Subject: Duke Energy Carolinas, LLC (Duke Energy)  
Oconee Nuclear Station Units 1, 2, and 3  
Docket Numbers 50-269, 50-270, and 50-287  
Relief Request 10-ON-002 Request for Additional  
Information (RAI) Response

Oconee Nuclear Station Units 1, 2, and 3  
Relief Request 10-ON-02 Request for Additional Information (RAI)  
Response

Cross-Sectional Coverage Plot

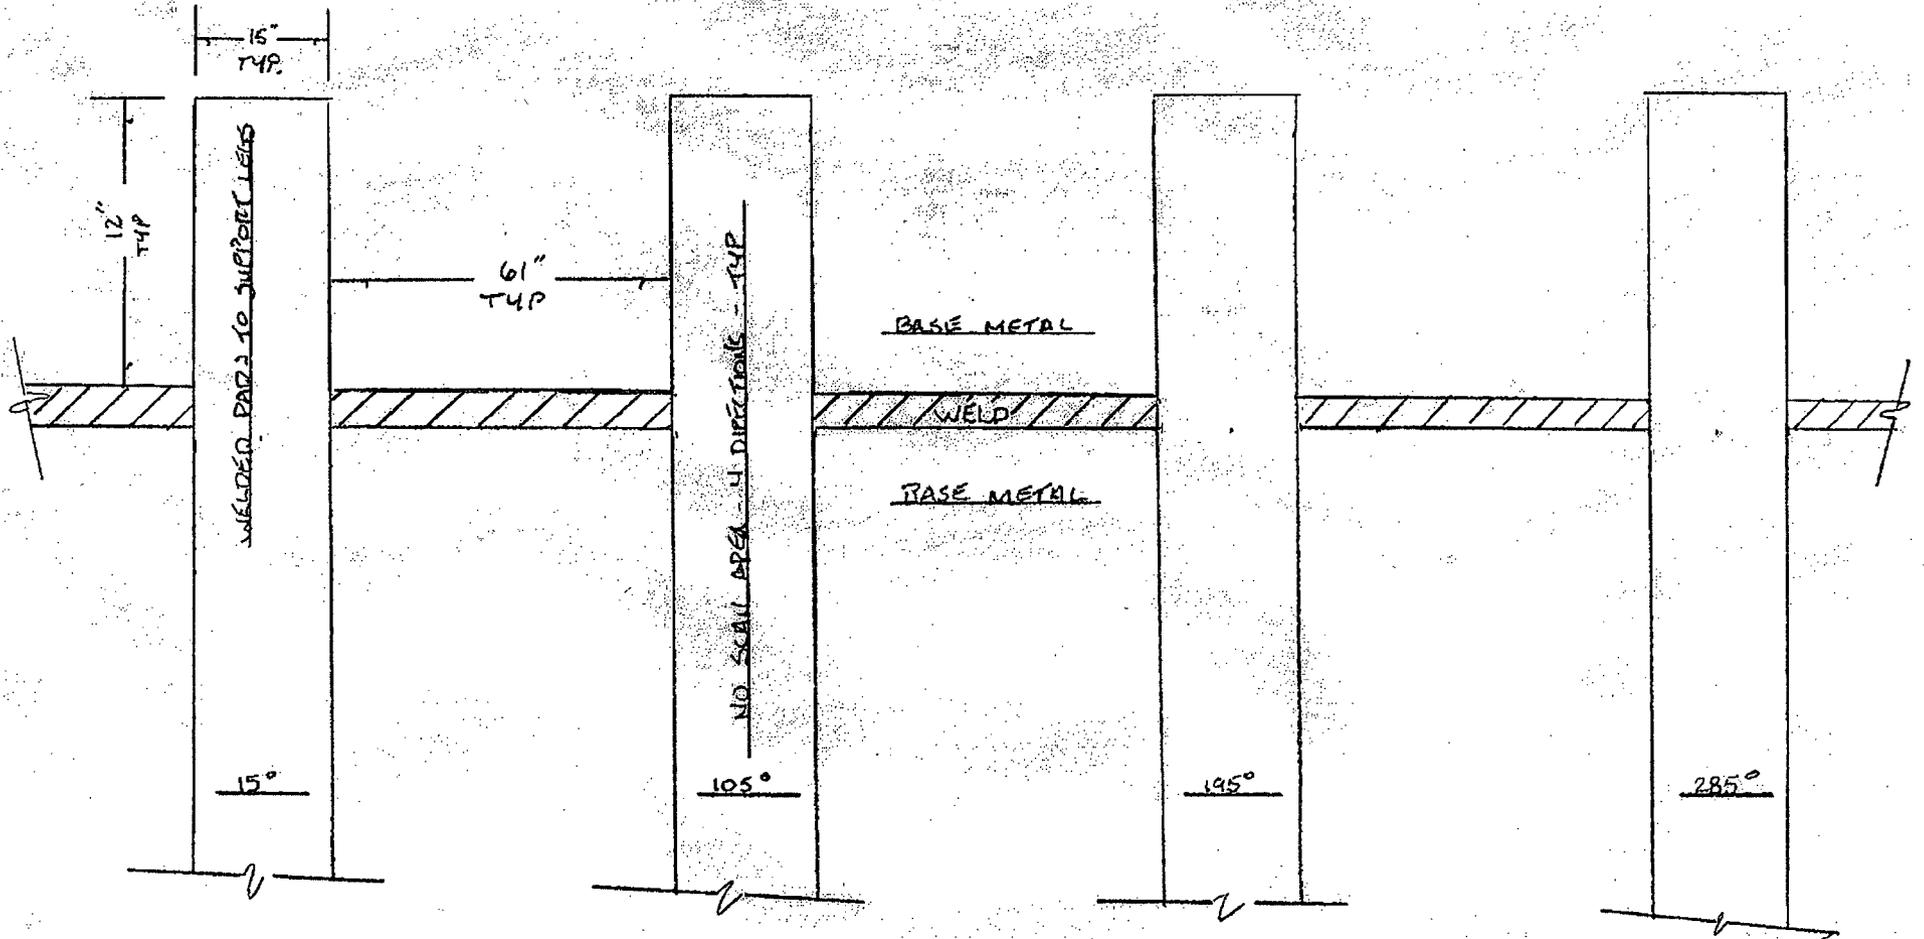
- 2.3.d) Provide cross-sectional coverage plots to describe ASME Code volumes examined.

Duke Response: Cross-sectional coverage plots are provided in Attachment A of the RAI response. Each of these two welds was limited due to the presence of four weld pads that completely restricted any scanning in the area of the weld pads. The four weld pads completely covered the weld and adjacent base metal. The examination achieved 100% coverage in the accessible areas.

Site/Unit: Oconee / 1  
 Summary No.: O1.C5.11.0076  
 Workscope: ISI

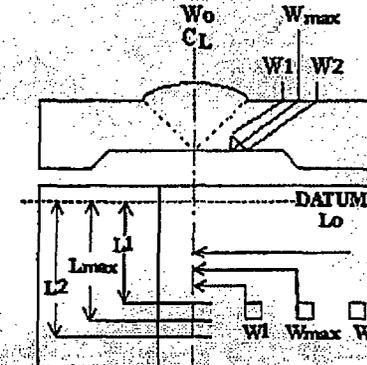
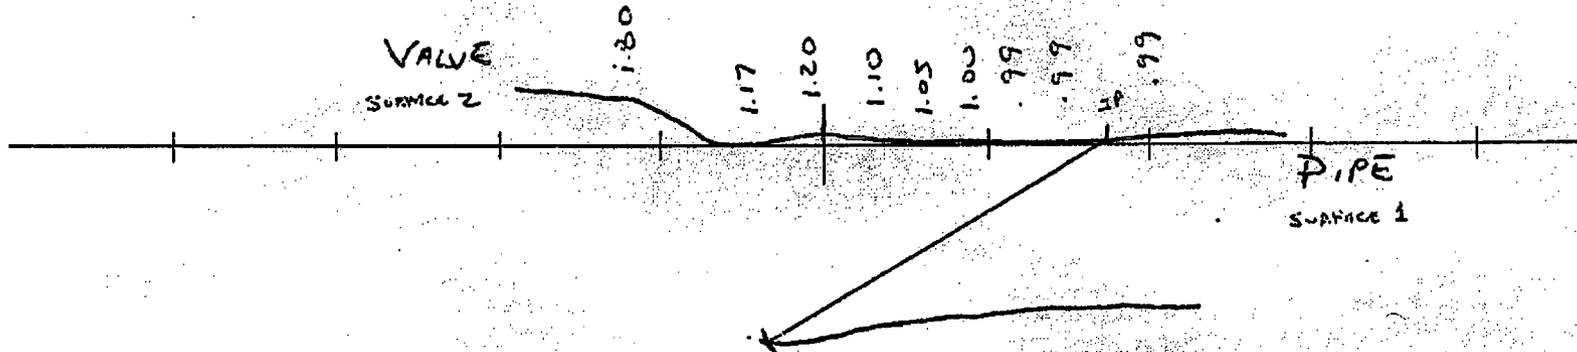
- 2.4.b) Clarify whether any indications were discovered as a result of ASME Code-required examination and how these indications have been dispositioned.

Duke Response            The two examinations of welds 3HP-501-23/O3.C5.21.0058 and 1LP-208-4/O1.C5.11.0076 (see Attachment B) produced recordable indications that required dispositioning. The indications were dispositioned and determined to be geometric using EPRI procedure PDI-UT-2, Section 9.5.

Comments: Indication #1 - Determined to be geometry - 360 INT.
